Meeting Agenda

Historic Zoning Commission

Monday, September 30, 2024

S-4

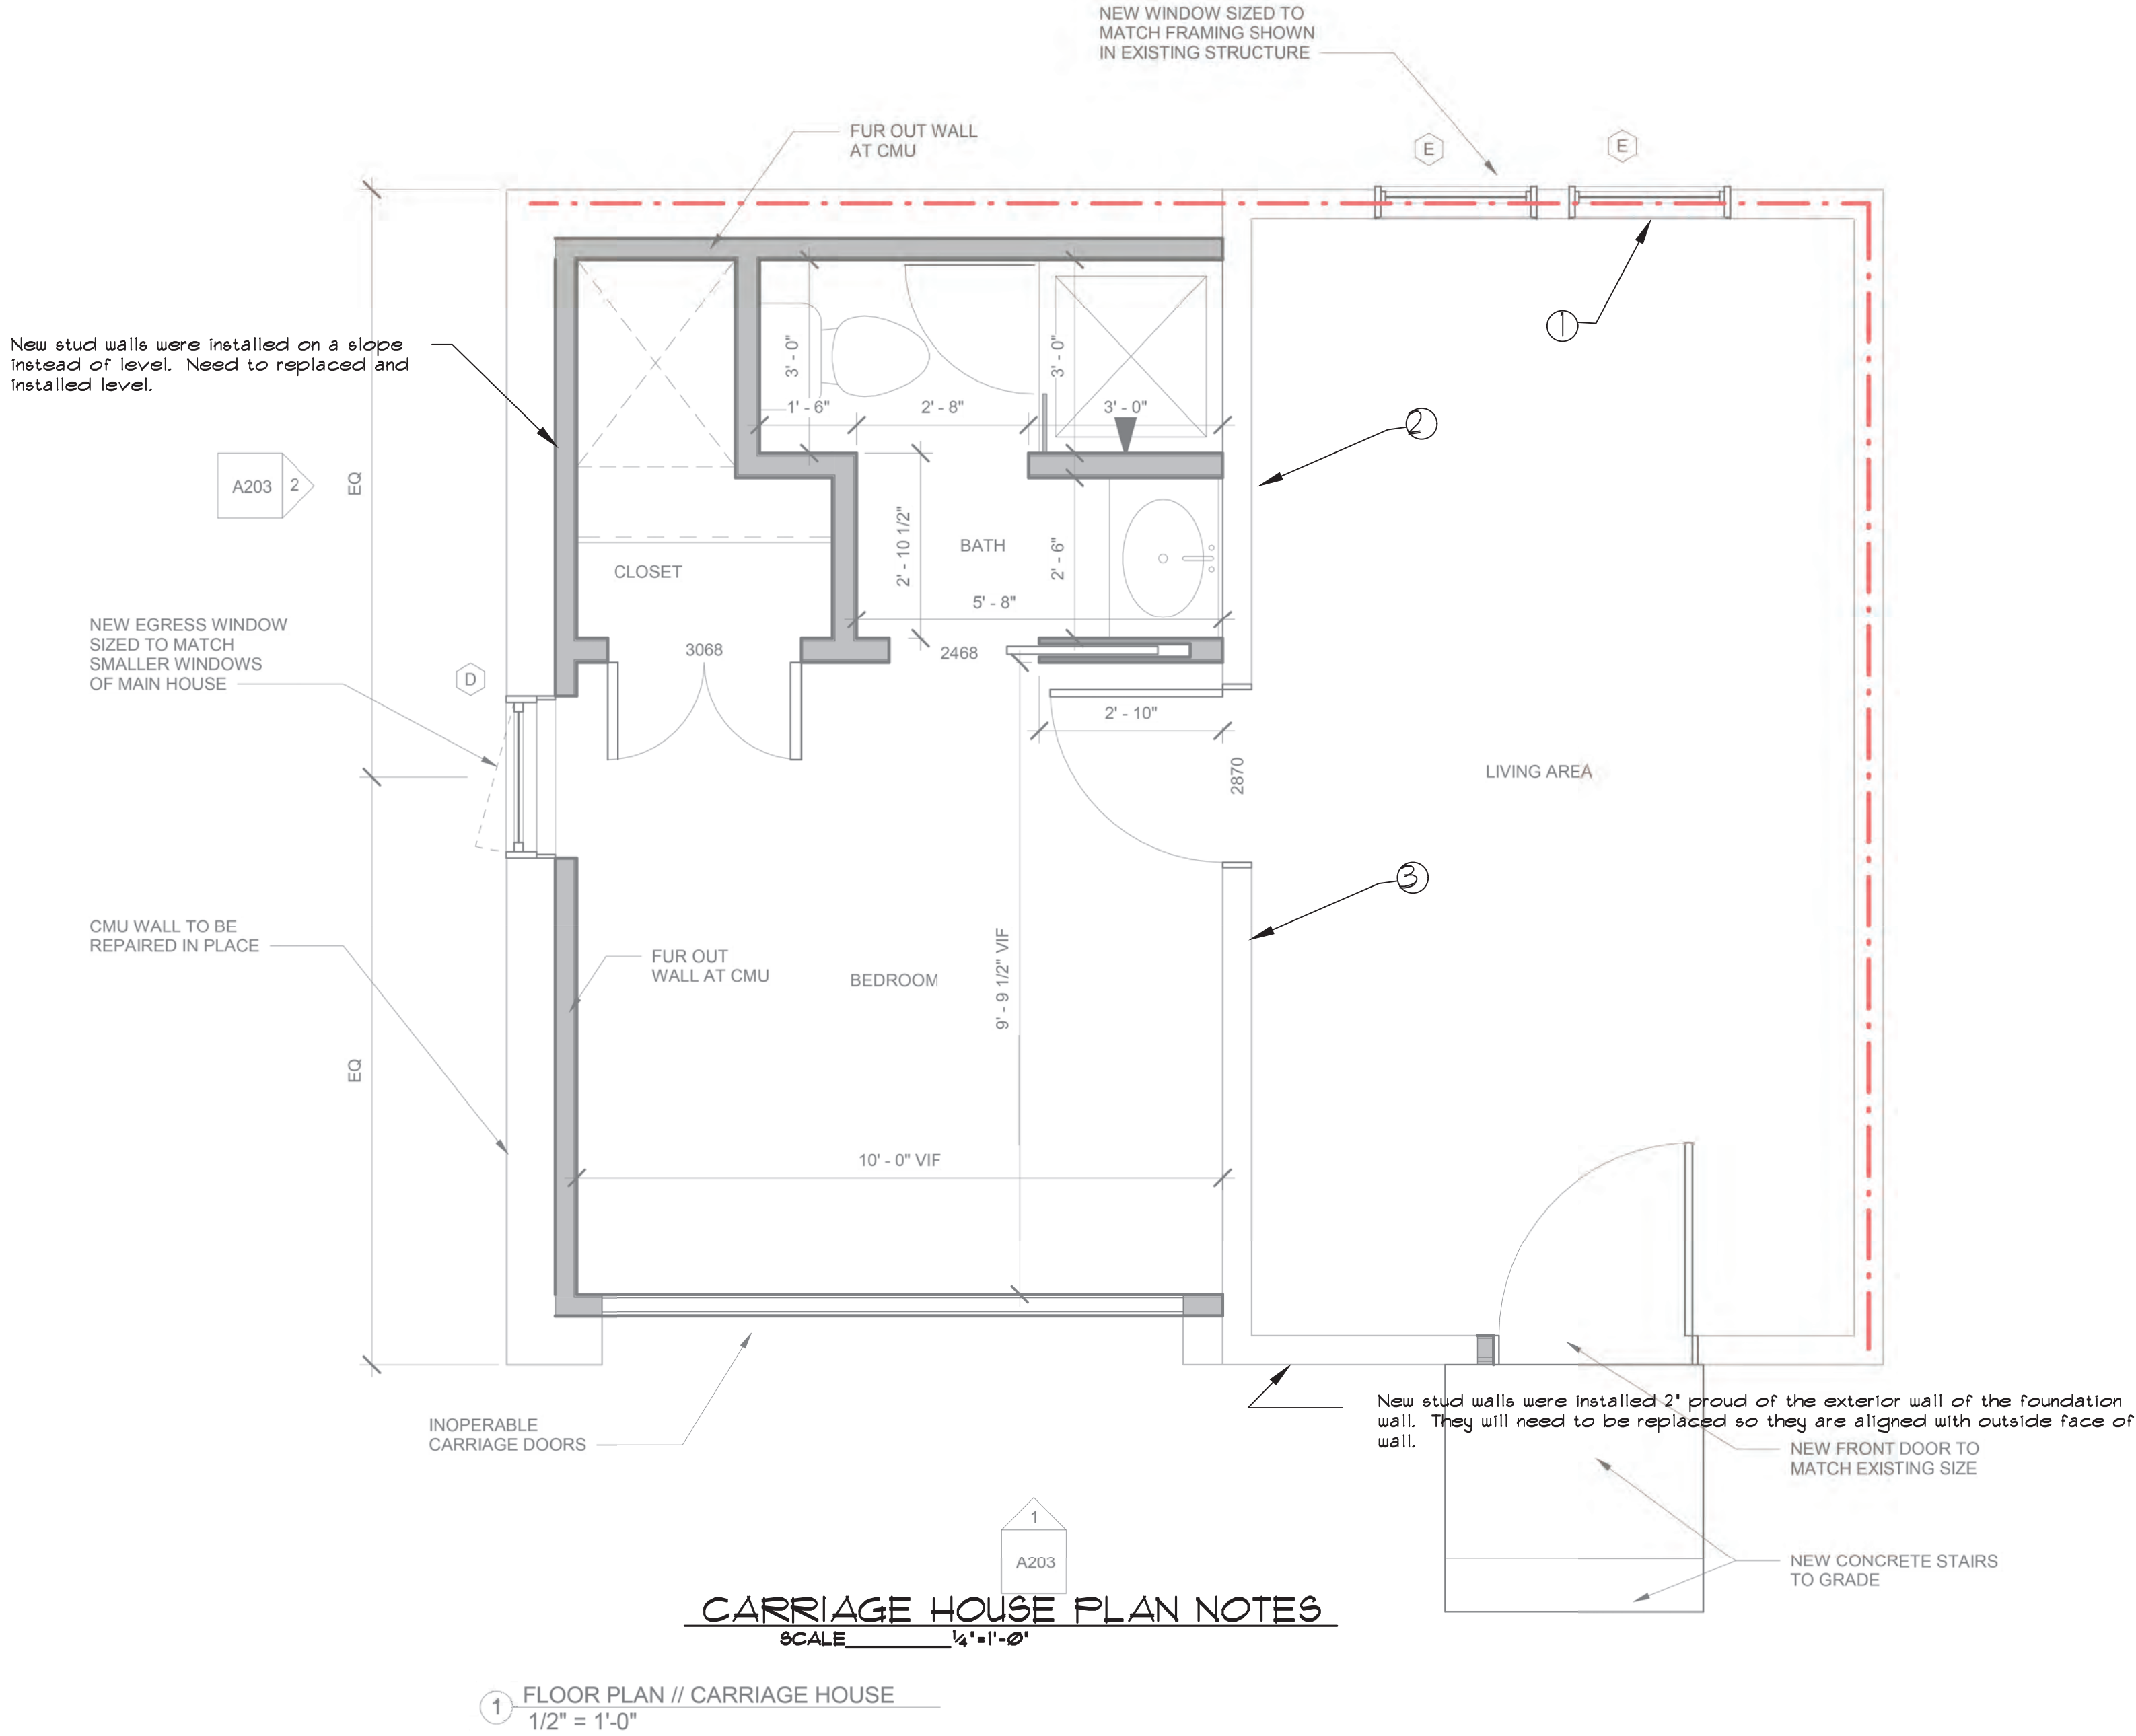
1 No anchor rods between sill and foundation wall.
Install 1/2" diameter x 5' Titen HDs at 32" oc.
